# Texas Commission on Environmental Quality

## Attachment 2 – NOD Responses

Municipal Solid Waste Permit Amendment No. 1848A  
 Beck Landfill  
 6<sup>th</sup> Notice of Technical Deficiency

BECK LANDFILL  
GUADALUPE COUNTY, TEXAS  
TCEQ PERMIT APPLICATION NO. MSW 1848A

NOD Response 10 – Revised Part III, Attachment F, Appendix F-1 –  
Monitor Well Data Sheets

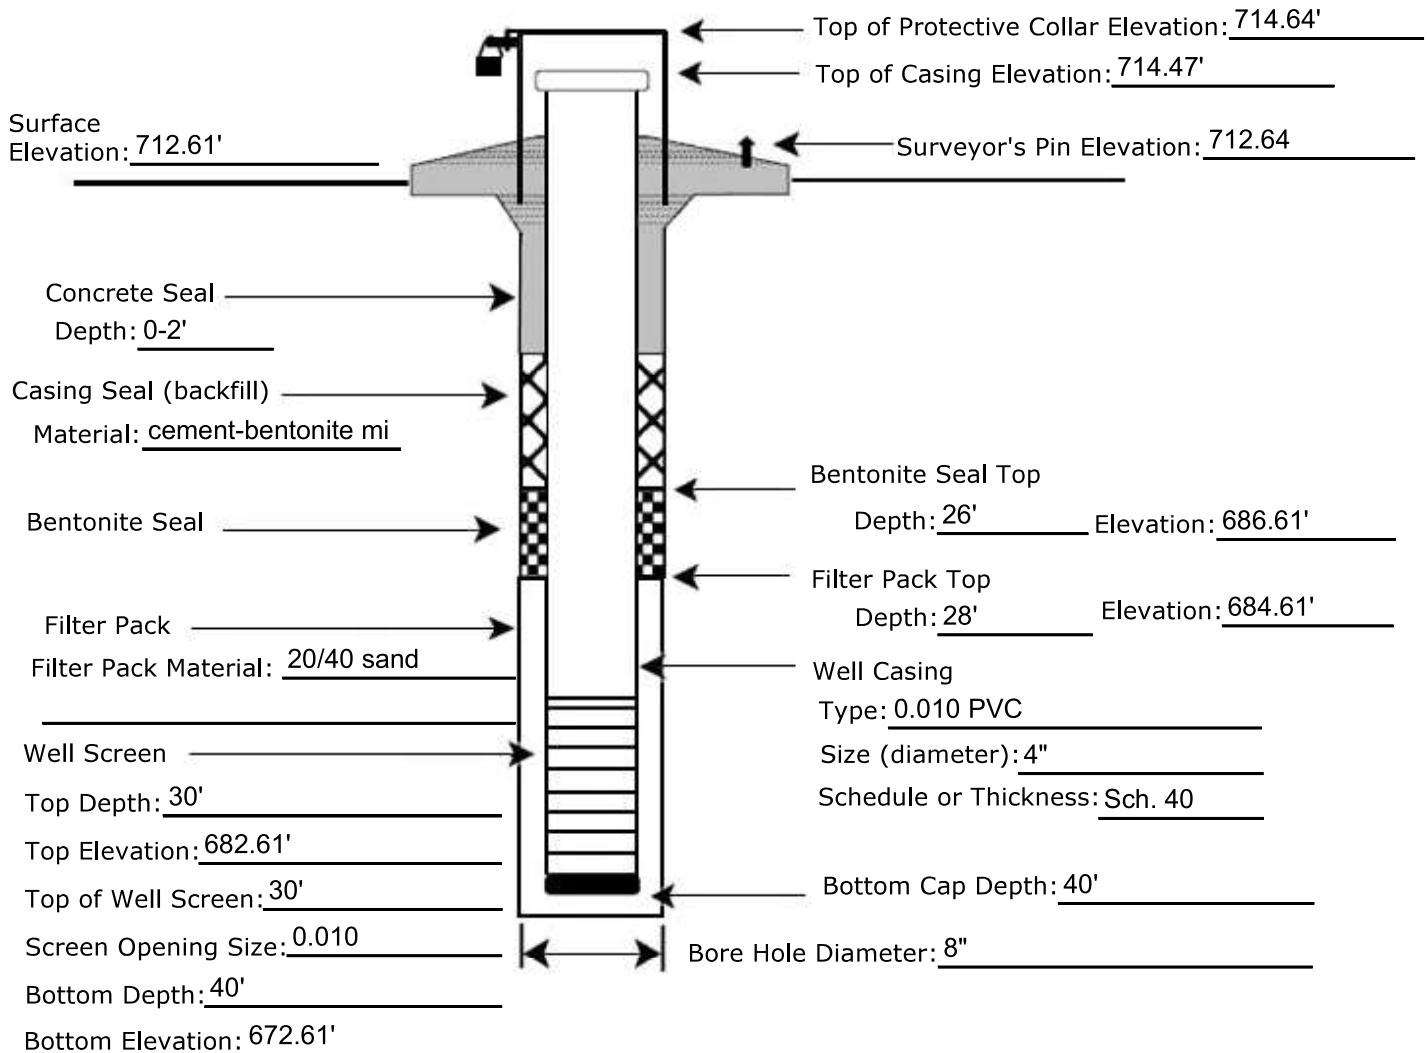
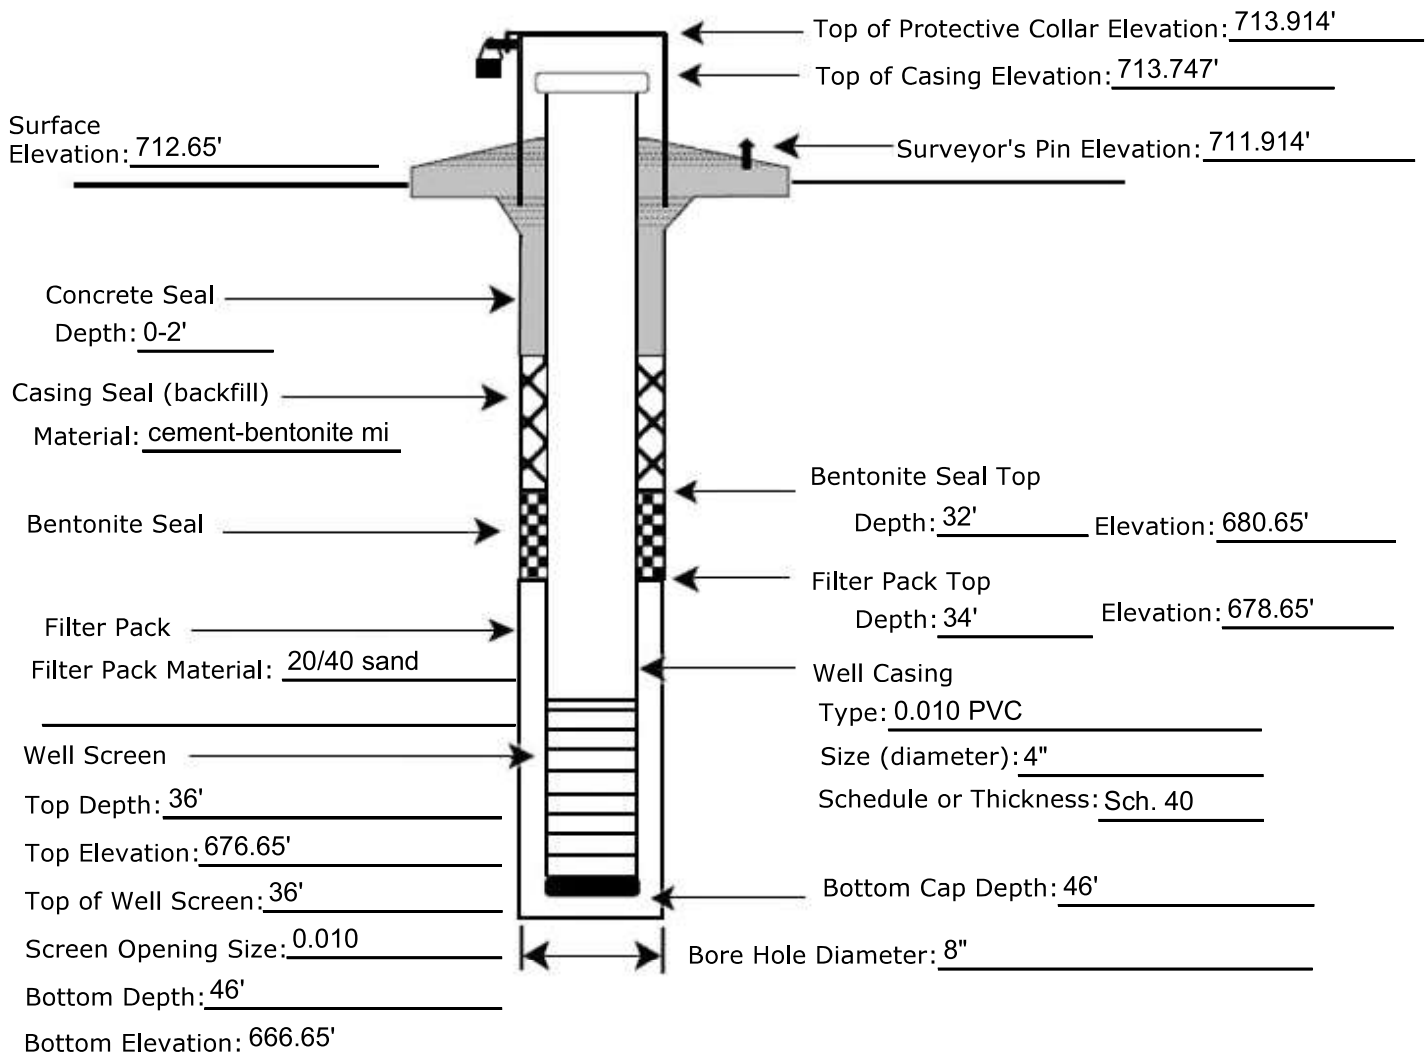
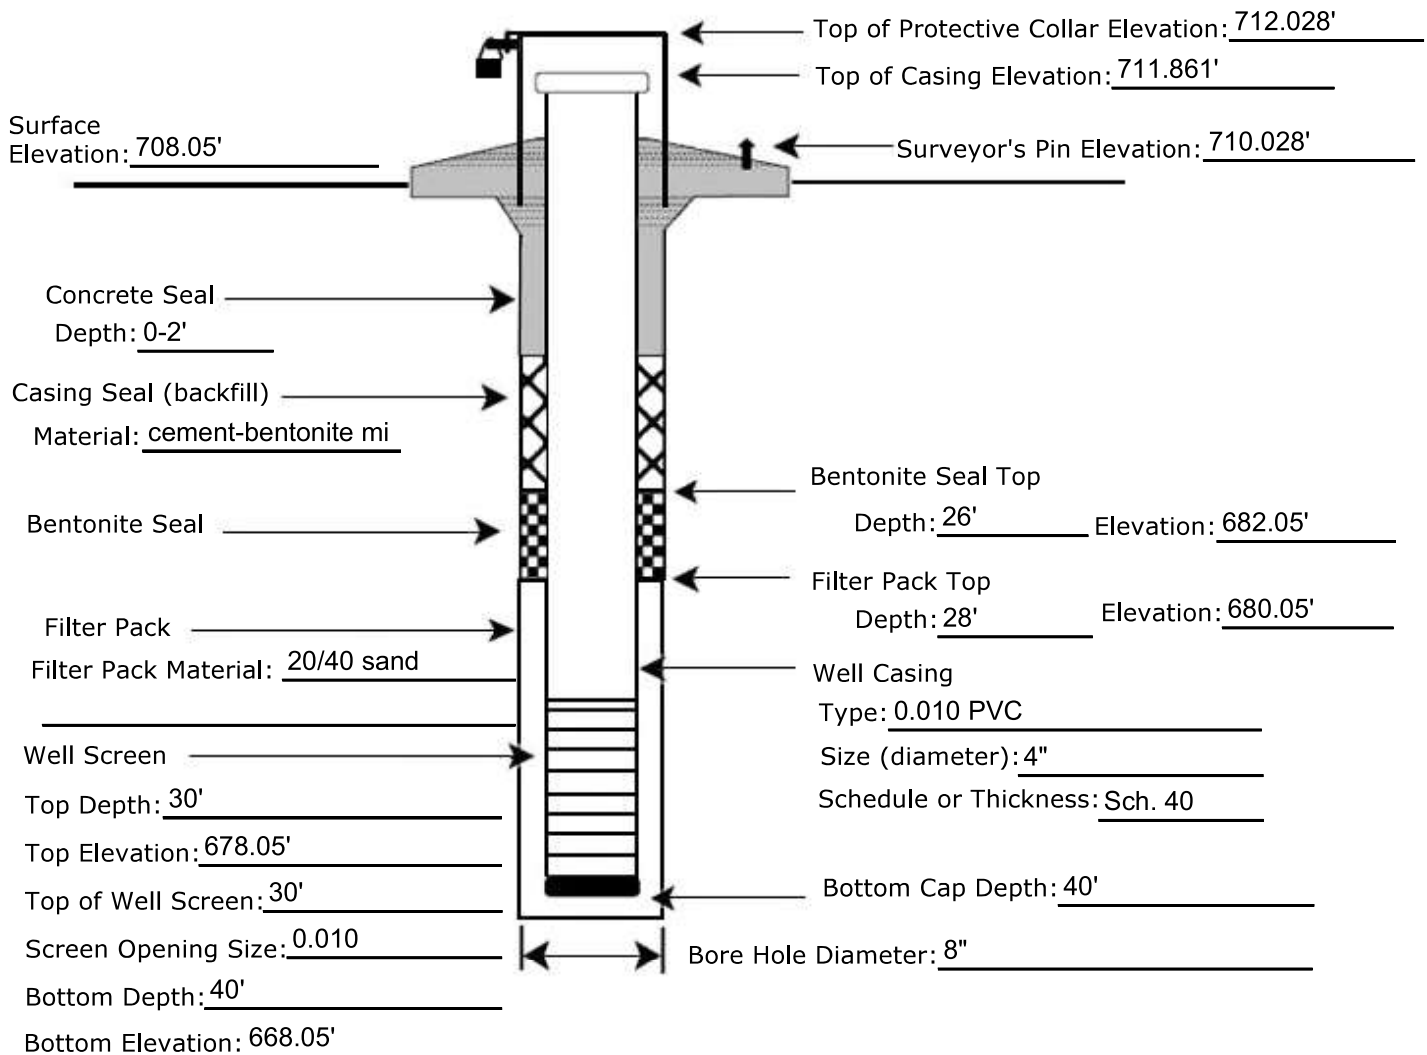
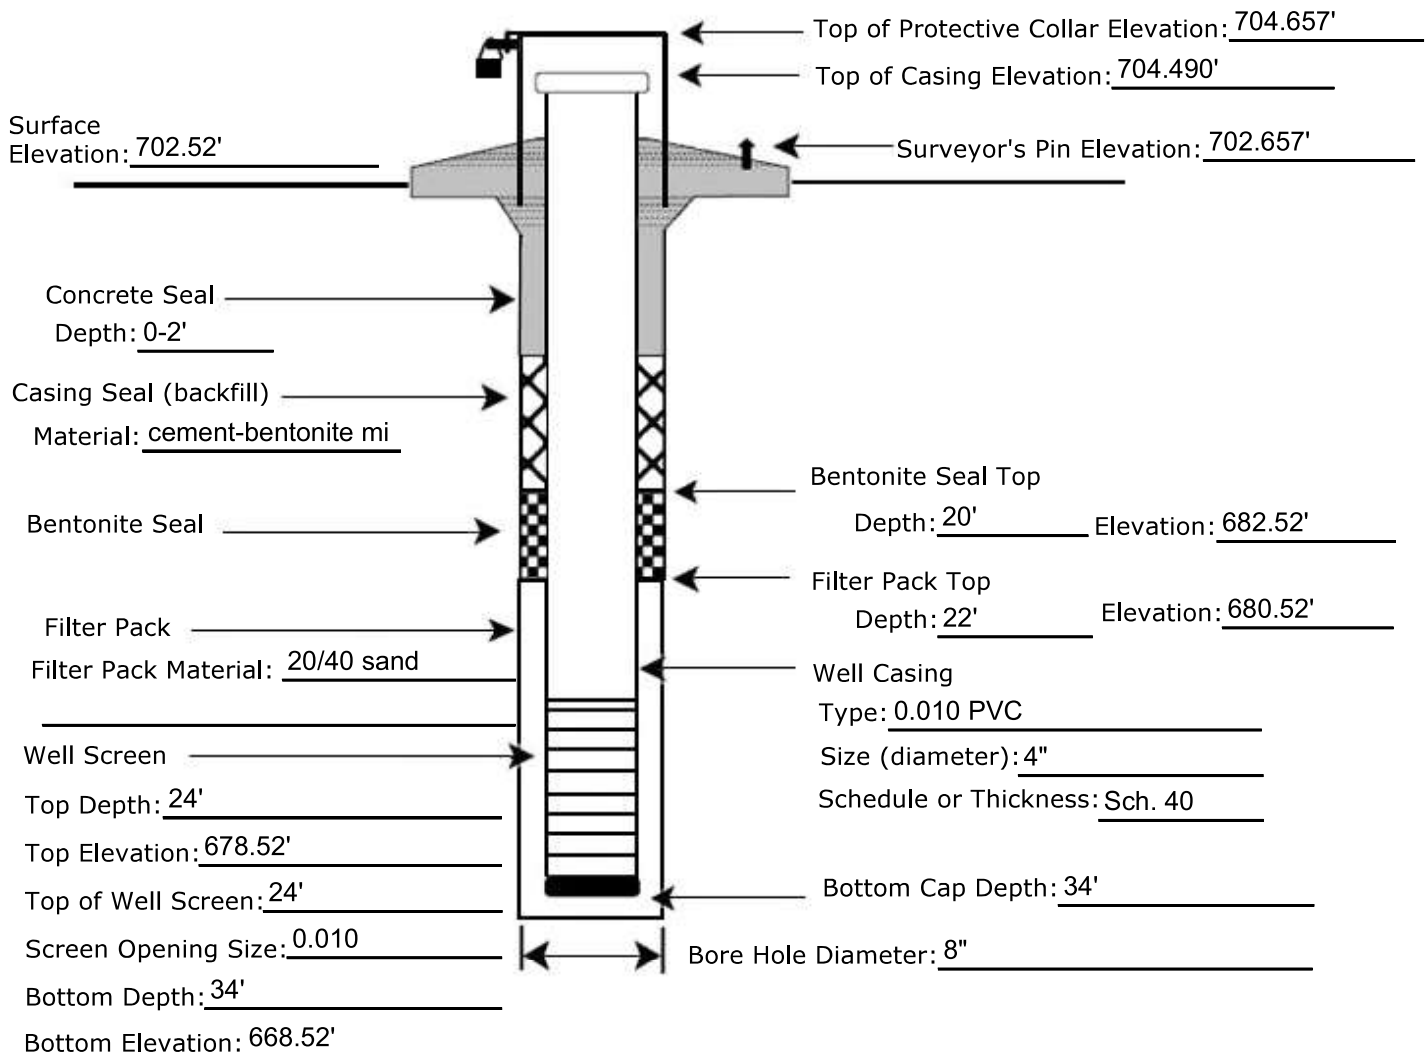
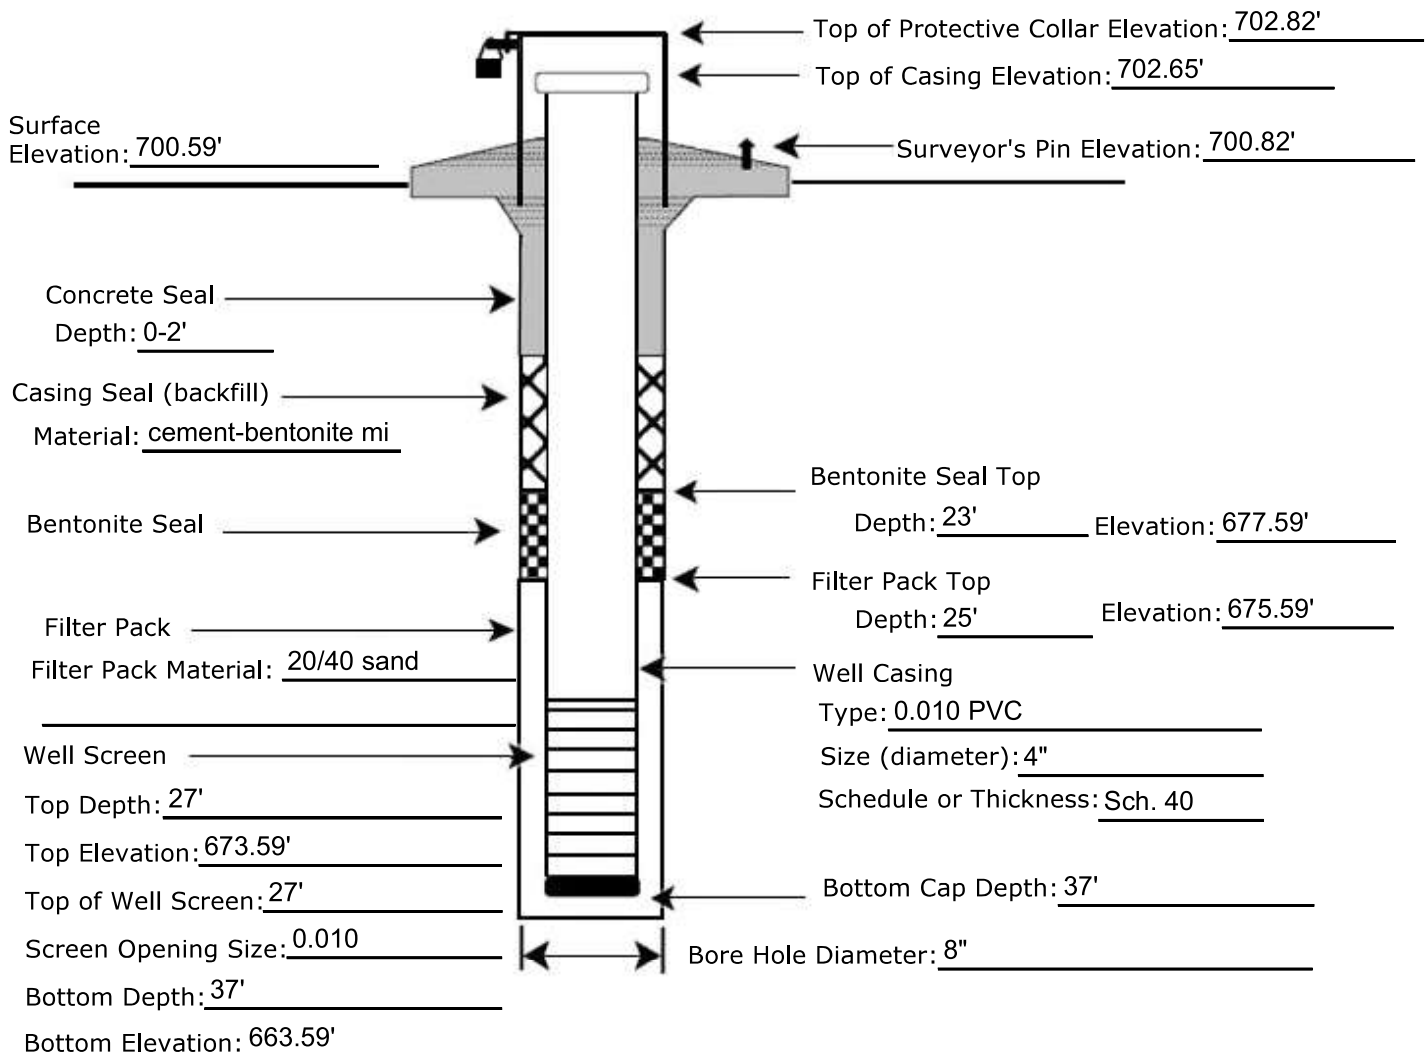
| NOD ID | MRI ID | Citation | Location                             | NOD Description  | Response   |
|--------|--------|----------|--------------------------------------|--|--|
| 10     | 634    | 330.421  | Part III, Attachment F, Appendix F-1 | Confirm whether the clearance (approximately 0.3 inches) indicated on the monitor well and piezometer data sheets between the tops of casings and the protective covers of the flush-mount surface completions is correct. | A 24" stick up and protective cover is installed around each monitor well (not piezometers). Three sets of data sheets are provided in this response: the original sheets (do not show the stick up), the 2000 updates resulting from replacing MW-D (show the stick up), and a new set on the updated TCEQ form that show historical data with new pad survey elevations (taken in October 2023). POWER has relied on historical information for well construction details below the ground surface and is carrying forward the historically permitted and accepted designs through this process. |

A 24" stick up and protective cover is installed around each monitor well (not piezometers). Three sets of data sheets are provided in this response: the original sheets (do not show the stick up), the 2000 updates resulting from replacing MW-D (show the stick up), and a new set on the updated TCEQ form that show historical data with new pad survey elevations (taken in October 2023). POWER has relied on historical information for well construction details below the ground surface and is carrying forward the historically permitted and accepted designs through this process.
